## **BUILDING, ZONING, & REVITALIZATION COMMITTEE**

Re: MCPC # 15-0214-001

Plan Name: Glanzmann Subaru – 101 Old York Road  
(1 lot/4,510 sq. ft. comprising approximately 0.70 acres)

**Reference: Glanzmann Subaru – 101 Old York Road  
Preliminary Land Development  
Jenkintown Borough, Montgomery County, Pennsylvania  
Nave Newell No. 2014-103.00**

Attachment A: Reduced Copy of Applicant's Plan  
Attachment B: MCPC Comments on Applicant's Plan  
Attachment C: Aerial Photograph of Existing Site  
Attachment D: Sample Photographs

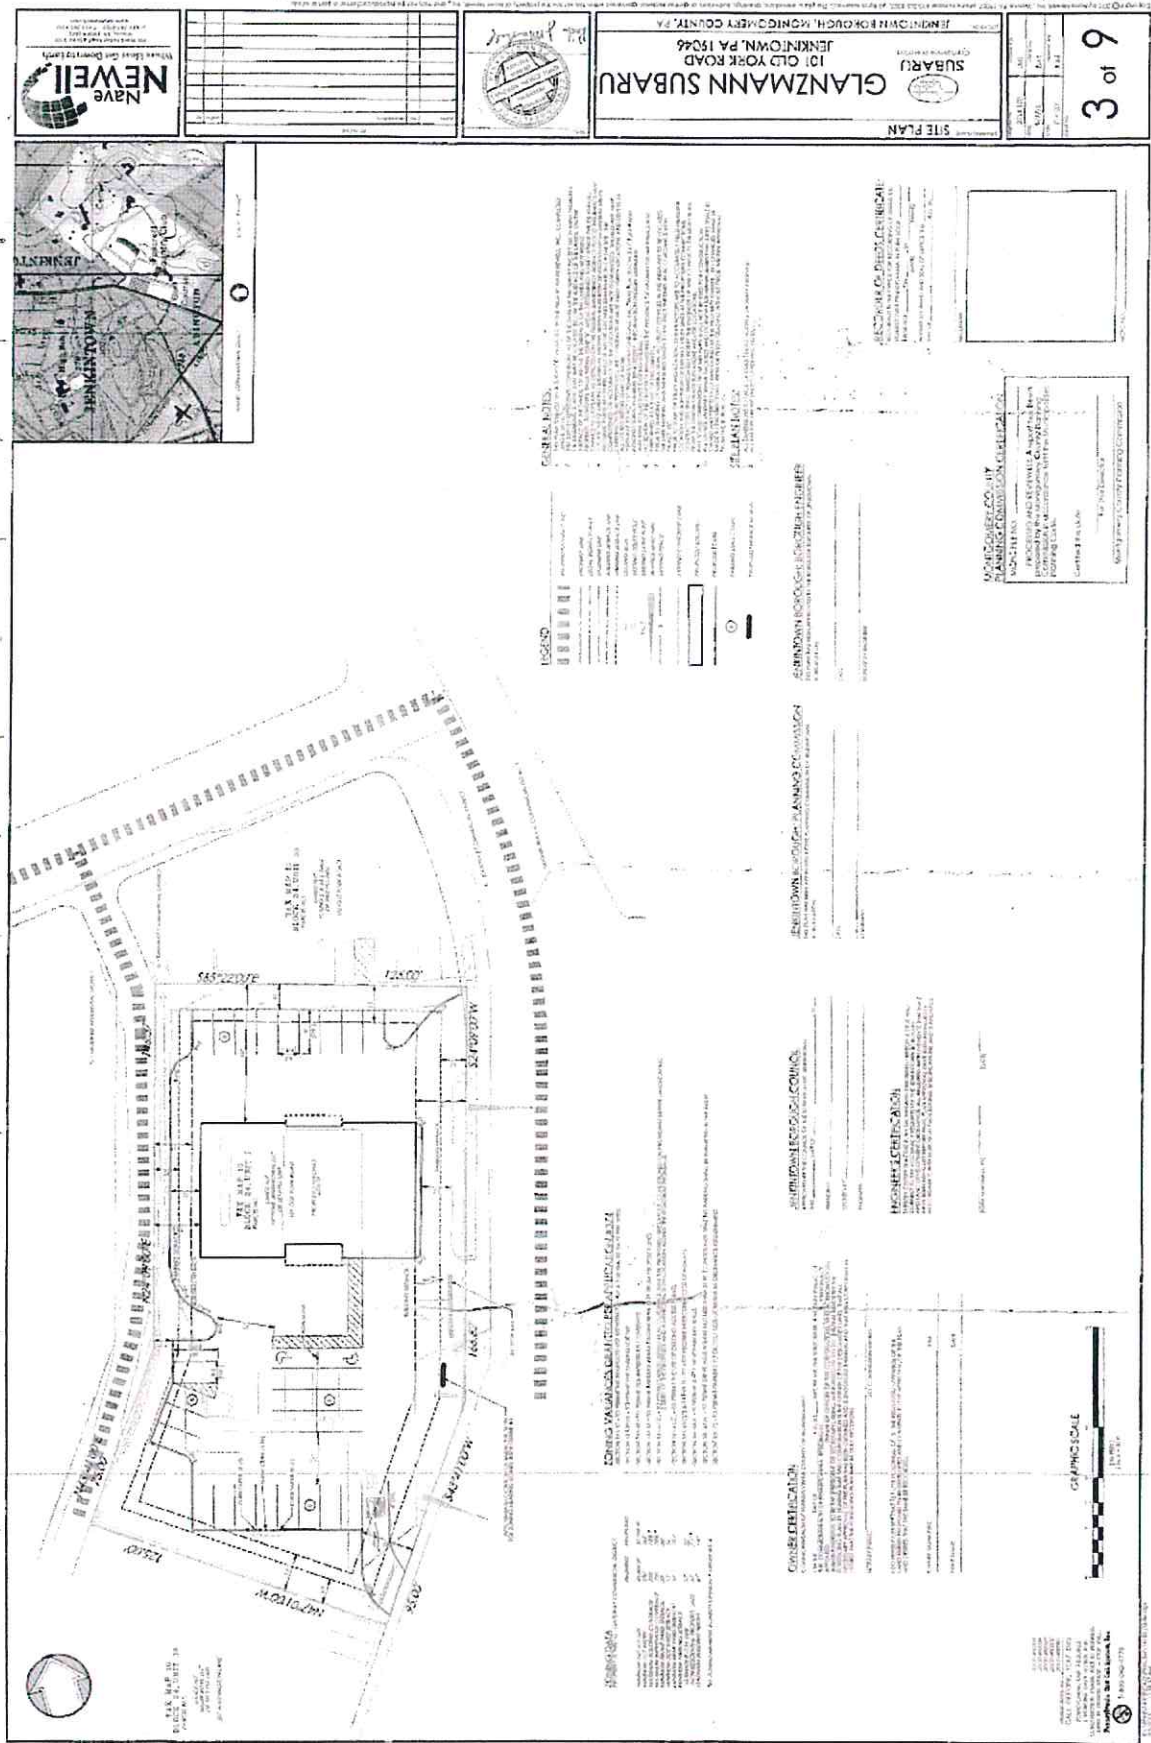
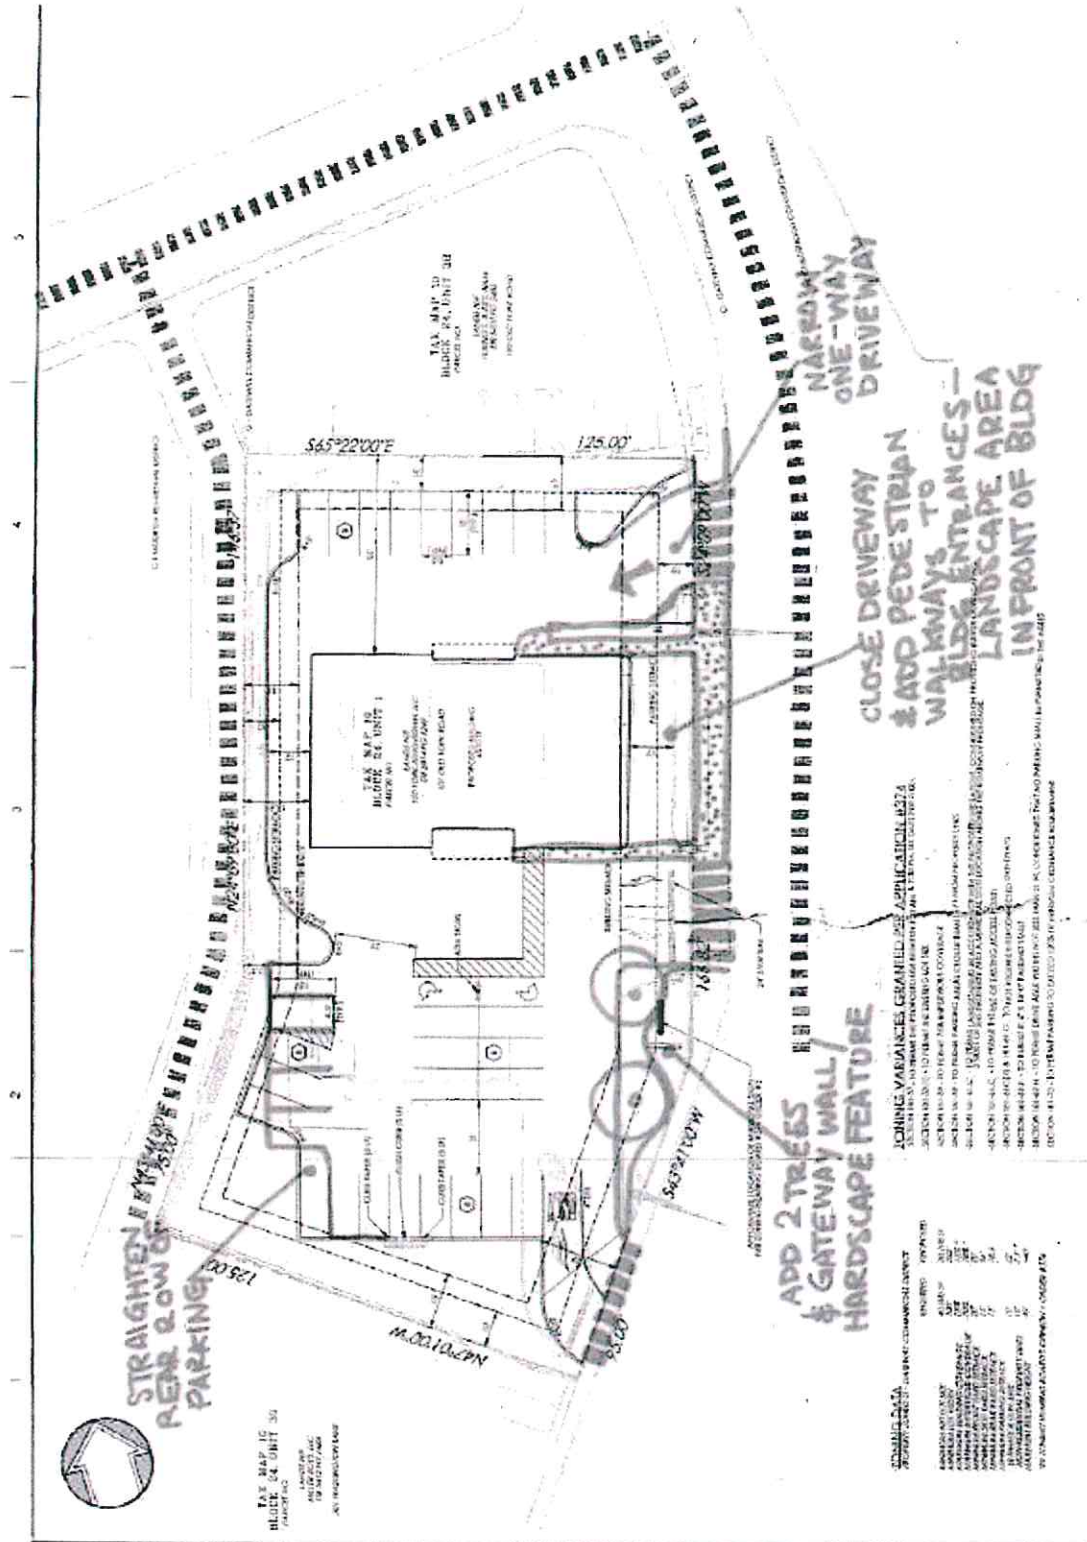
Although the applicant received several variances from the ZHB that allowed them to increase the number of parking spaces on the site, some of the parking spaces are configured so that conflicts between vehicles may arise. In particular, the two, semi-perpendicular rows of parking in the southwestern corner of the property are placed very closely together and at an odd angle. We feel that there is not enough space for vehicles in this corner to safely maneuver the parking spaces. We recommend that the row of parking spaces closest to the alley be straightened and that the last parking space in the row of spaces along the southern property line be eliminated in order to improve the parking lot circulation. This recommendation is illustrated in Attachment B.

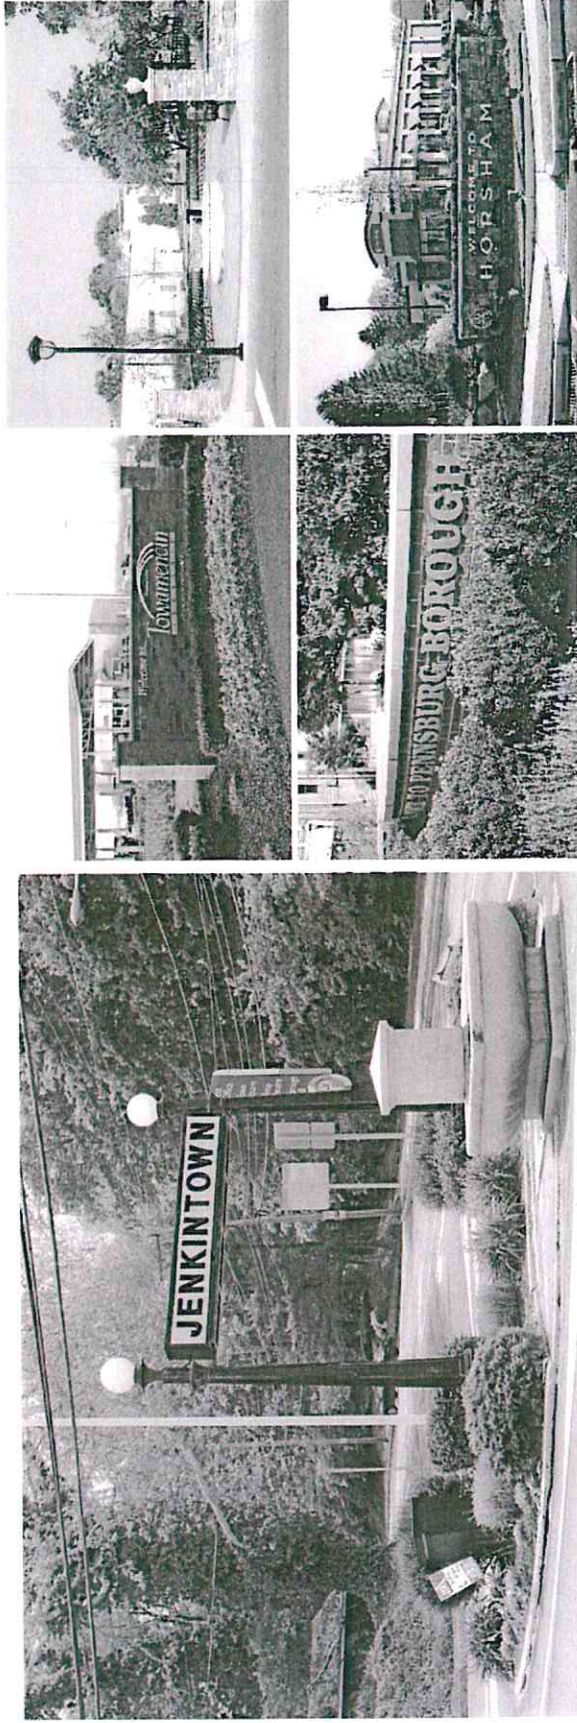
Although the applicant received a variance from the parking lot landscaping requirements from the Zoning Hearing Board, the ZHB decision stated that the applicant must still develop landscape plans for the Washington Lane and Old York Road frontages of their property that is consistent with the intent of the Gateway zoning and consistent with similar gateways in the Borough, such as Greenwood Avenue near the railroad (see photos in Attachment D).

The current gateway at Greenwood Avenue (left) near the railroad provides a distinctive entrance to the Borough through a combination of signage, landscaping, and a fountain structure. There are many examples (right) of attractive local gateways incorporating seating, hardscape materials, and landscaping that have been developed locally through public-private partnerships. (Source: MCPG)

The BMW of the Main Line currently under construction on Bala Avenue in Lower Merion Township incorporates a public parklet, street trees, and clear pedestrian connections to the main entrances of the building. The building is built-up to the sidewalk and additional amenities for customers, such as outdoor seating, are provided. (Source: BMW of the Main Line)
